Product / Process Change Notification (PCN)

PCN #: PCN_UtRJ45LAN_20181008

Affected Series: WE-RJ45LAN; 7499xxx

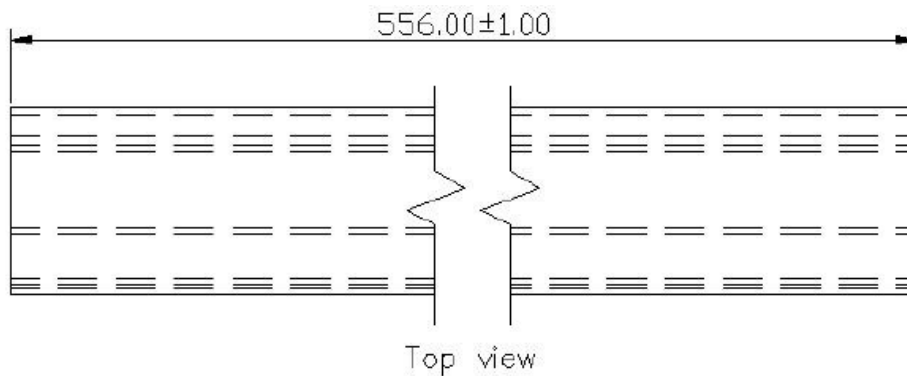
The tube lengths will be changed from 556.00 ±1.00 mm to 530.00 ±1.00 mm.

<p>OLD</p> <p>556.00±1.00</p> <p>Top view</p>	<p>Affected part numbers:</p> <p>7499110120 7499210123 7499210210 7499010122 7499010126 7499010124</p>
<p>NEW</p> <p>For the part numbers on the right column, the packaging quantity won't change</p> <p>530.00±1.00</p> <p>Top view</p>

OLD

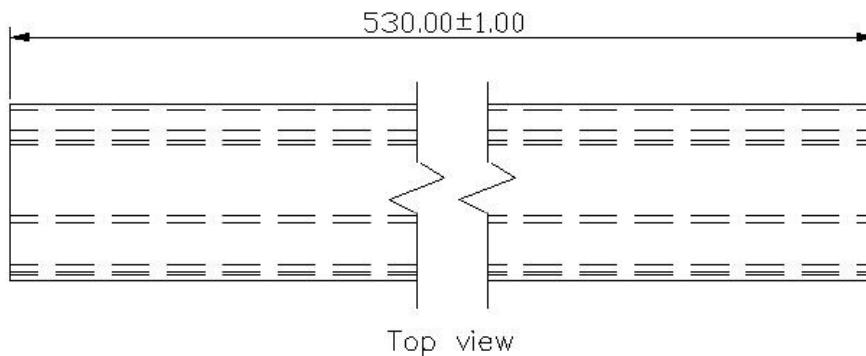
Affected part numbers:

7499012000
74990110013
7499010213
7499010005
7499011215
7499111213
7499111443
7499011002
7499011121
74990111215
7499011125
74990112120
7499111990
7499210121
7499210122
7499210211
7499211121
7499211123
7499012121

For the part numbers on the right column, the packaging quantity won't change

**OLD**

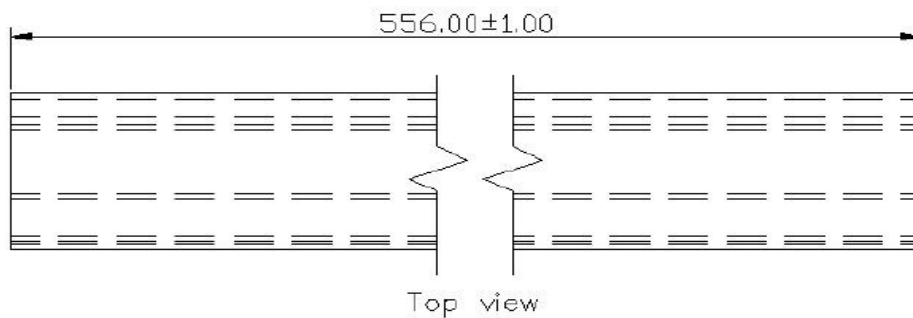
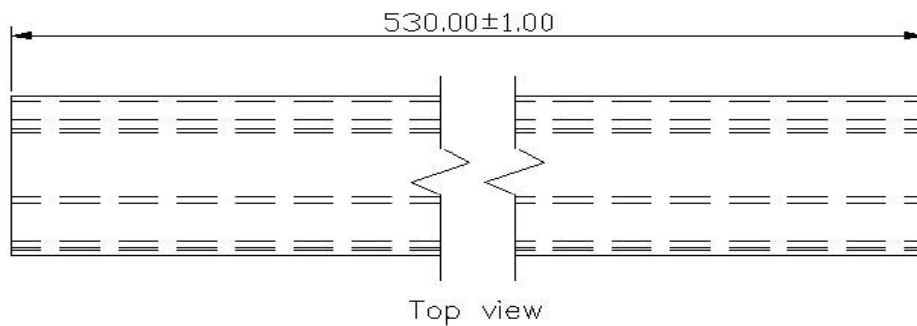
Packaging quantity:

20 pcs. per tube**20 tubes** (=400 pcs. per carton)

Affected part numbers:

7499011211

7499111241

7499011225

7499011610

Packaging quantity:

19 pcs. per tube**20 tubes** (=380 pcs. per carton)**RELIABILITY / QUALIFICATION SUMMARY:**
